### REMARKS

Claims 1-18 are pending in this application. Claims 1-6 were variously rejected under 35 U.S.C. § 112, second paragraph. Claims 1-3, 7-9 and 13-15 were variously rejected under 35 U.S.C. § 103(a). Claims 10-12 and 16-18 were objected to. Drawing Figures 1 and 4 were variously objected to under 37 C.F.R. 1.84(p)(5).

Figure 1

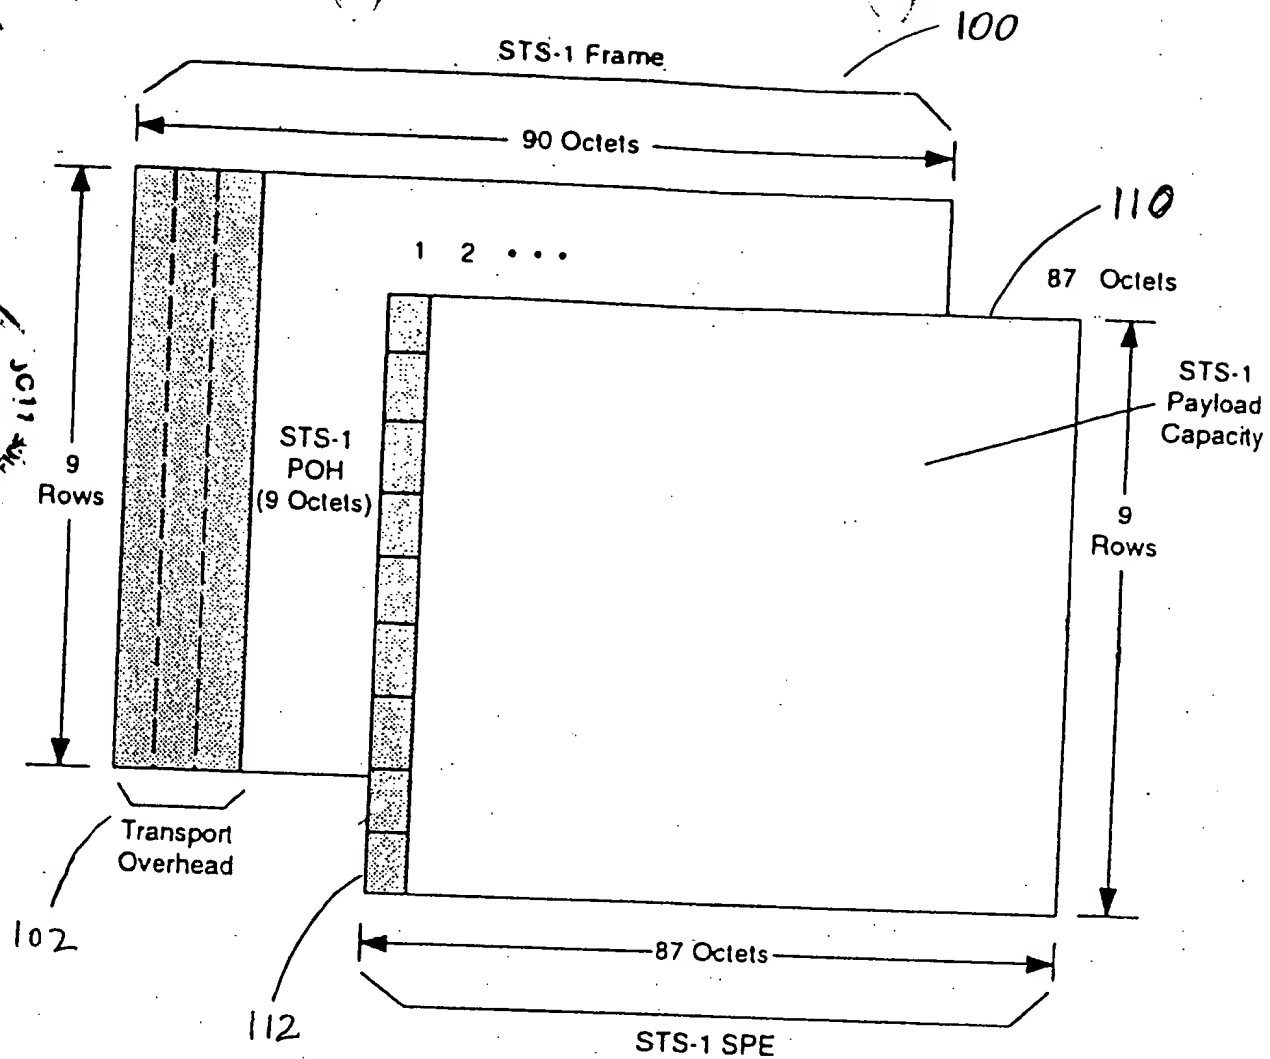
Regarding Figure 1, the Examiner stated that the following reference signs were mentioned in the description and not included in Figure 1: "'first column 210,' 'SPE 200,' 'POH data 210' (see page 2, lines 11-13; Figure 1)." See 19 February 2004 Office Action, page 2 (hereinafter "Office Action"). The Examiner also stated that the following reference signs were

included in Figure 1 and not mentioned in the description: "Figure 1, '110,' '112.'" *See id.* Finally, the Examiner requested that Figure 1 be designated by a legend such as "--Prior Art--." *See id.*

Accordingly, Applicant has amended the specification paragraph at page 2, lines 1-16 to as follows: (1) "first column 210" (page 2, line 11) has been amended to "first column 112," (2) "SPE 200" (page 2, line 12) has been amended to "SPE 110," and (3) "POH data 210" (page 2, line 13) has been amended to "POH data 112." Reference signs "210" and "200" in the first paragraph of page 2, as originally filed, constitute typographical errors, which should have been labeled "112" and "110," respectively. Figure 1 contains no reference signs labeled "210" and "200," but does indeed include reference signs labeled "112" and "110" that match the written specification at page 2, lines 1-16, as now amended. Applicant's specification amendment of the reference signs "210" and "200" to "112" and "110," respectively, also moots the Examiner's objection that the reference signs "110" and "112" in Figure 1 are not mentioned in the description.

Figure 1 has been corrected to include the legend "--Prior Art--" per the Examiner's request.

FIG. 4

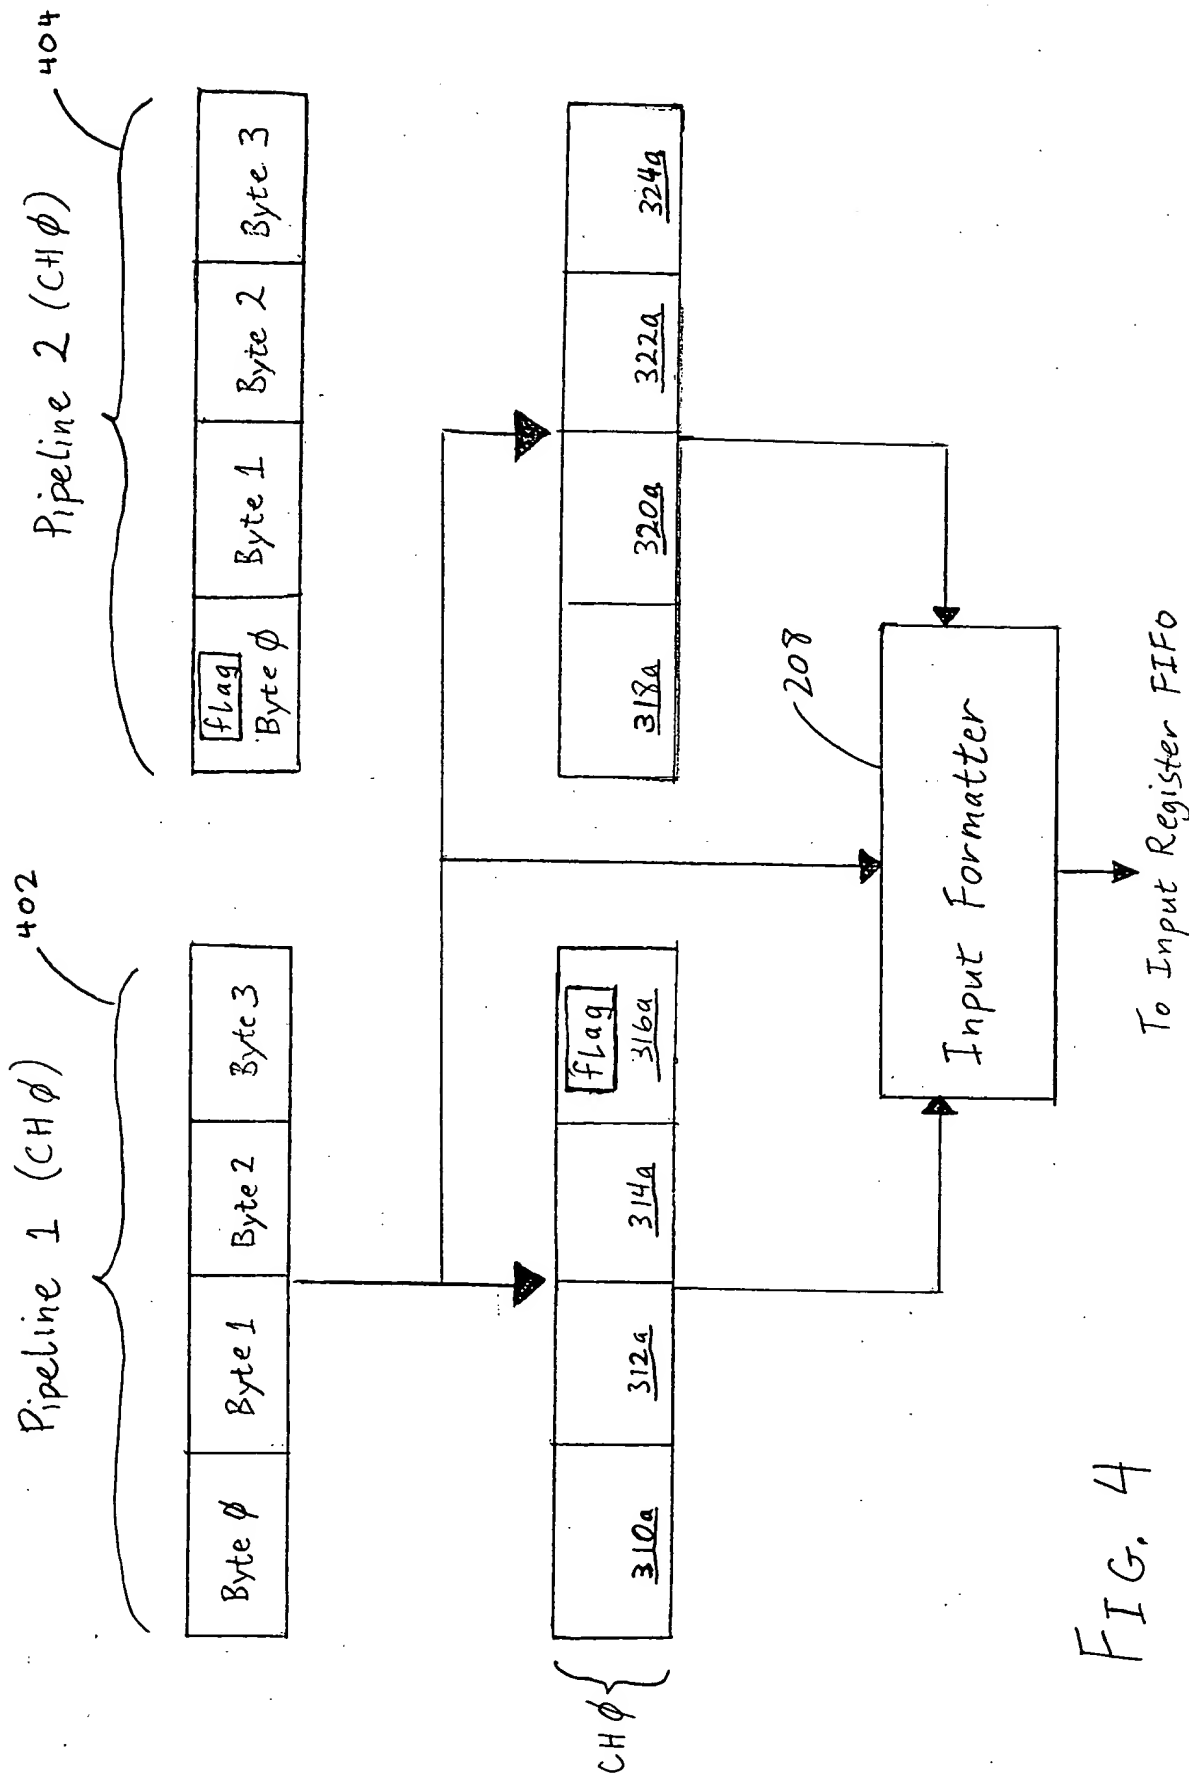
Regarding Figure 4, the Examiner stated that the following reference signs were mentioned in the description and not included in Figure 4: "'pipeline 402,' 'pipeline 404' (see page 1, lines 11, 19, 26, 28-29; Figure 4)." *See id.*

Figure 4 has been corrected to include the reference signs "402" and "404" per the Examiner's request. Corrected drawing Figure 4 includes the reference sign "402" near the text "Pipeline 1 (CH 0)" and the reference sign "404" near the text "Pipeline 2 (CH0)." These corrections are consistent with the written description language at page 11, lines 11, 19, 26, 28-29, referring to Figure 4.
